Tauranga City Council
21 Devonport Road
Tauranga 3143
New Zealand

BC330131 Request for Further Information #3 - Category 1 Geo-Professional Review

Awaiti Project Geotechnical Investigation and Desktop Summary Report

Mauao Viewing Platform	Mauao viewing platform.gsz Existing extreme GWL	Job Number: 4280807	Date: 13/04/2023
			Scale: 1:50	4280807-GA-K003

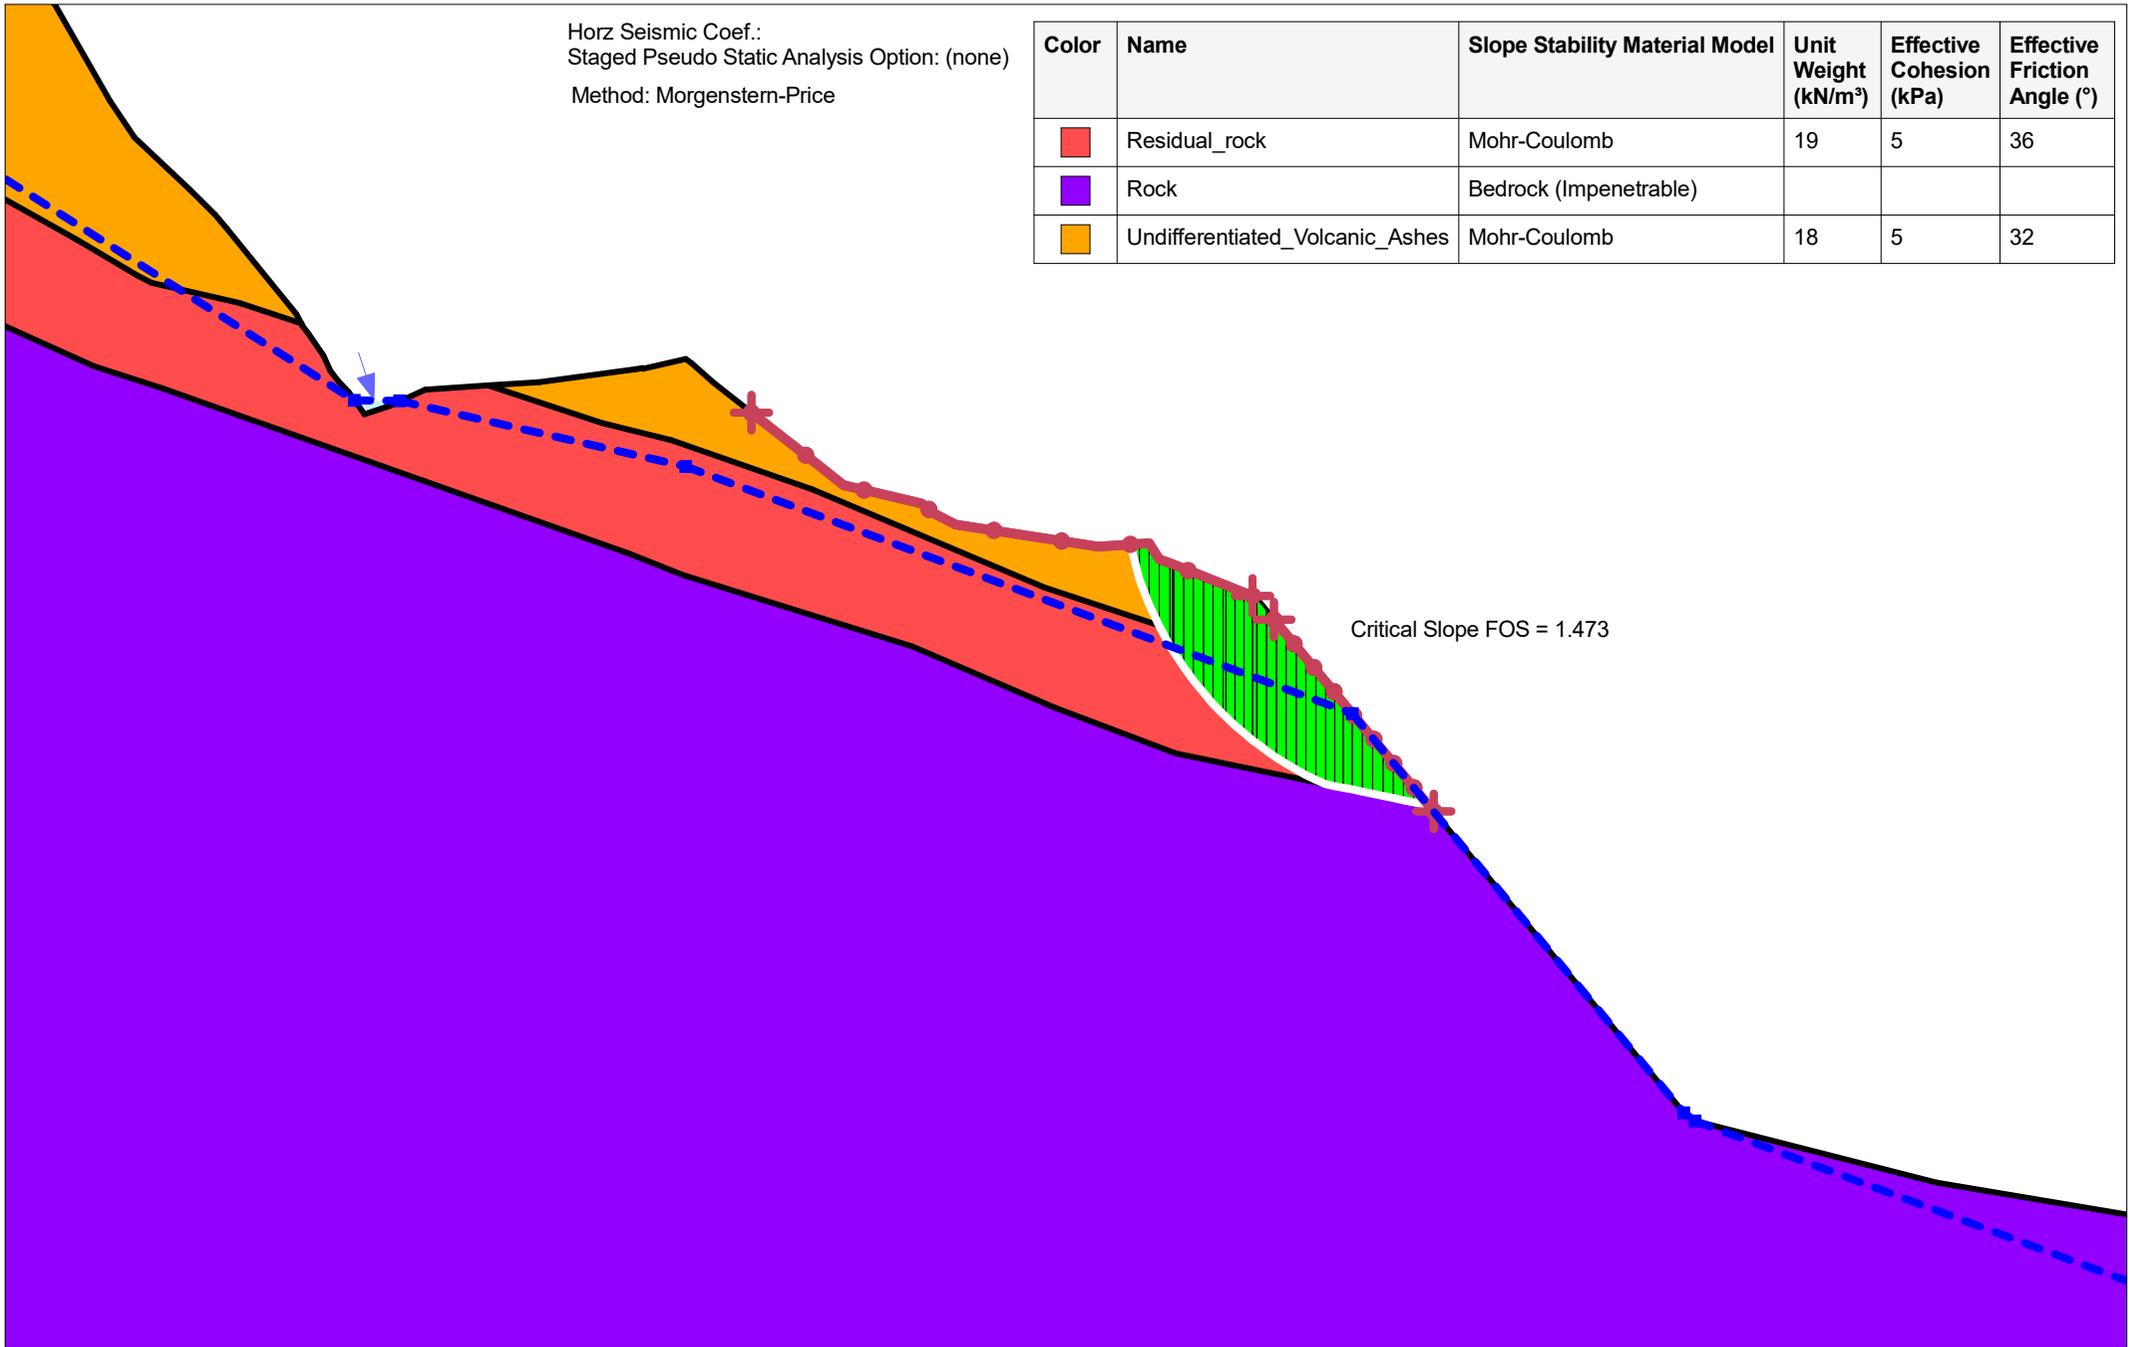
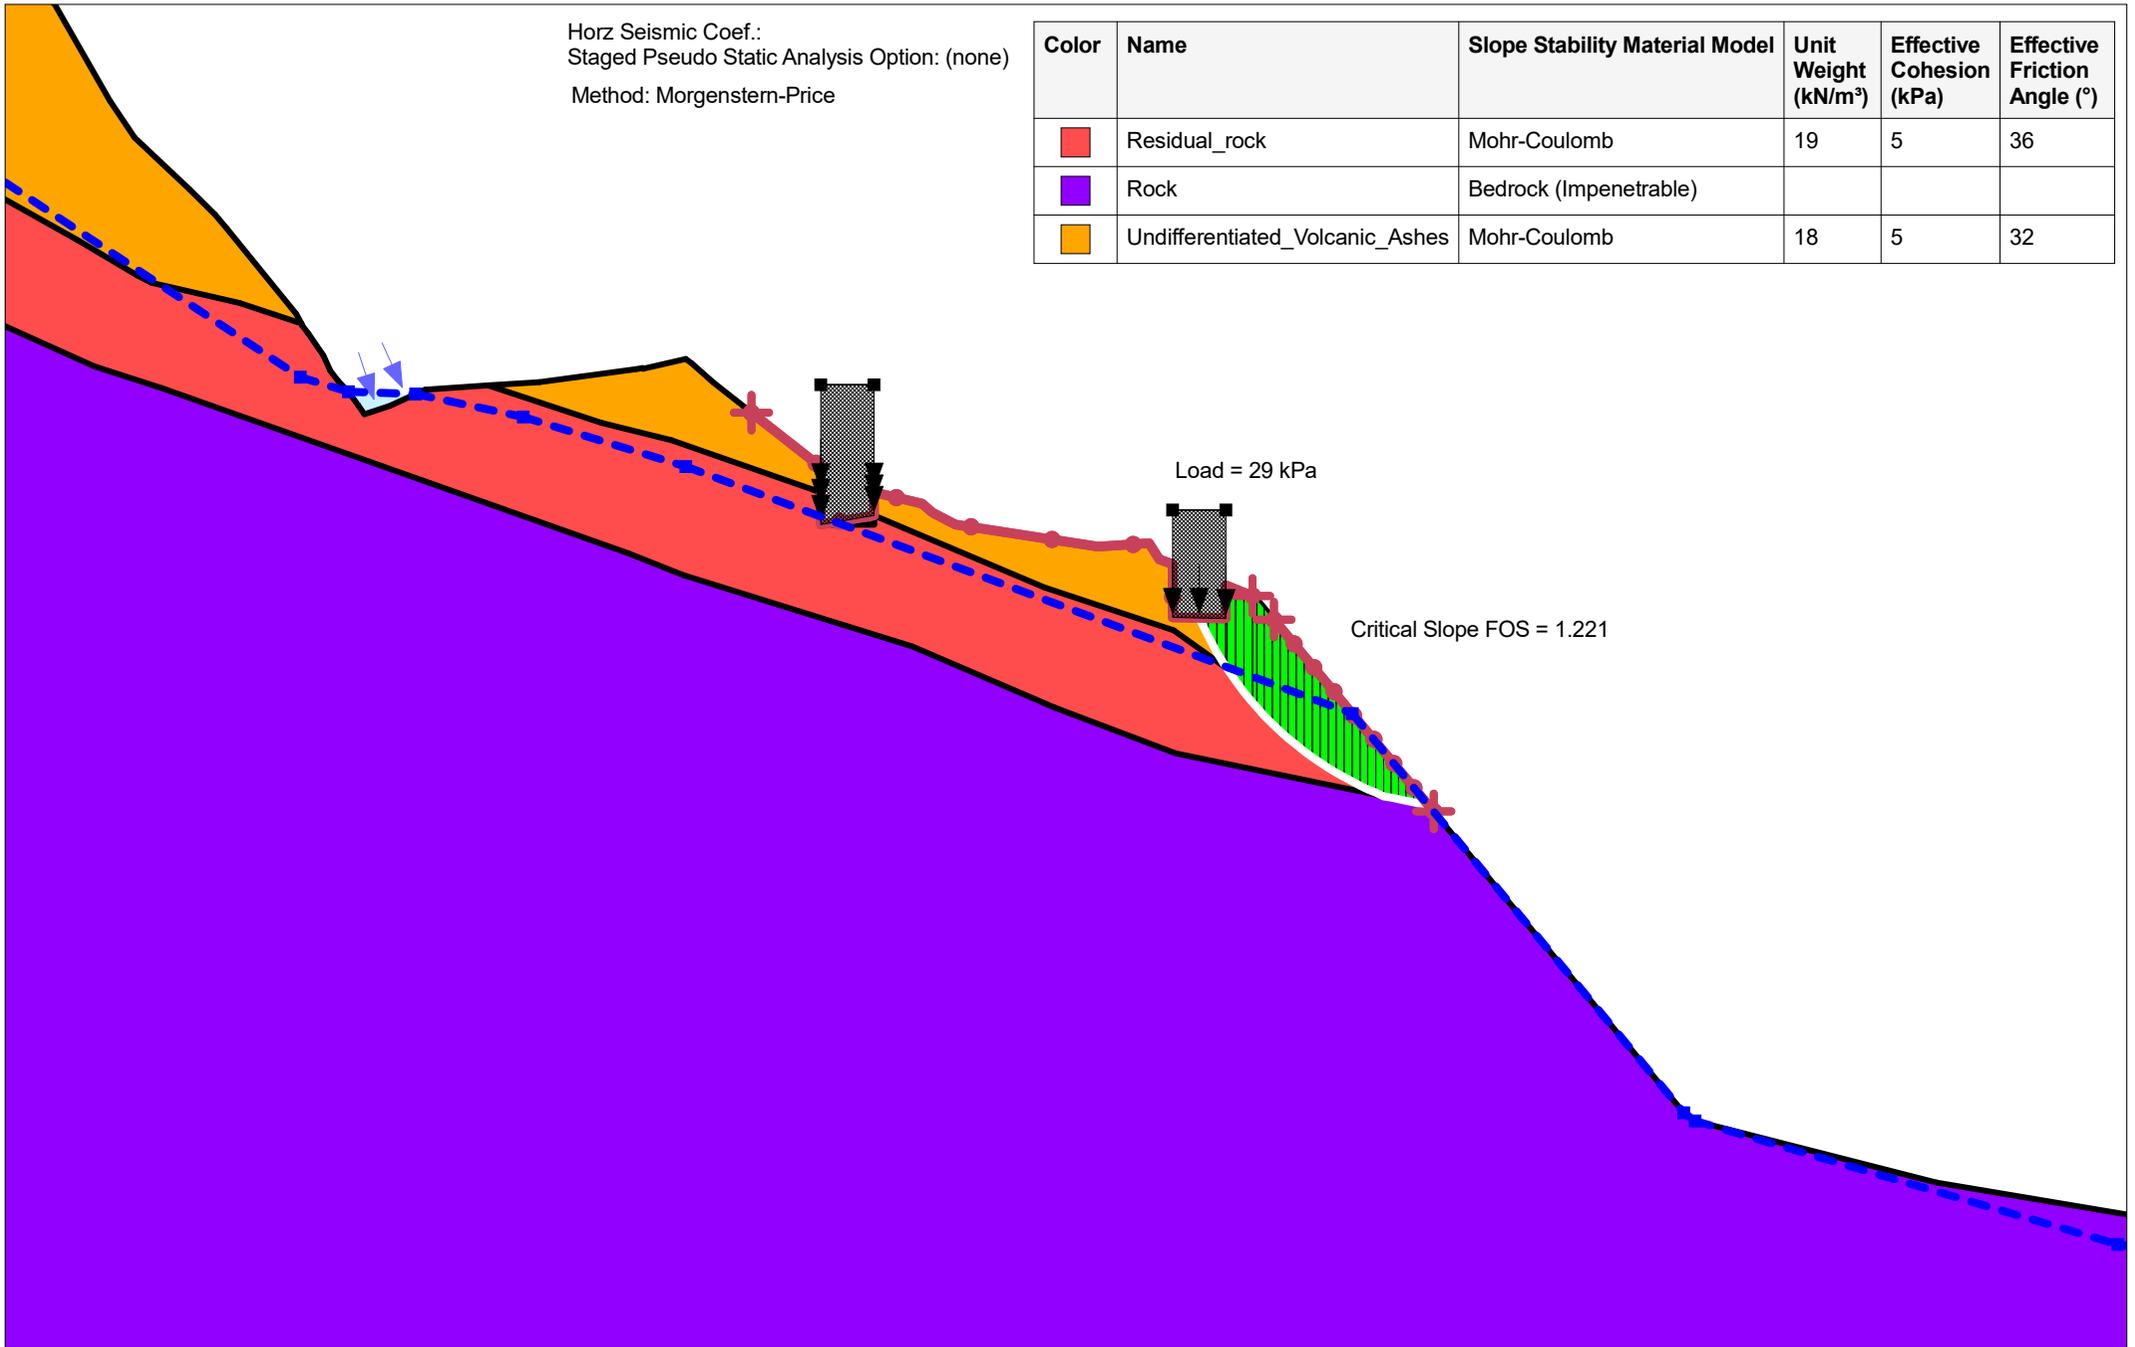
Question 1: Provide a review of the Beca geotechnical report dated 30/9/2022 from a Category 1 Geo-Professional and include a S72 assessment in respect to land stability.

We carried out analyses for the existing conditions and with the proposed structure. The results of the analyses are summarised in Table 1 below. In all cases the slope stability meets the minimum requirements of TCC IDC DS-10.

Case	Minimum Factor of Safety required	Existing	Proposed	Requirements met?
Static	1.5	1.87	1.54	Y
Extreme groundwater level	1.2	1.47	1.22	Y
Seismic	1.0	1.27	1.26	Y
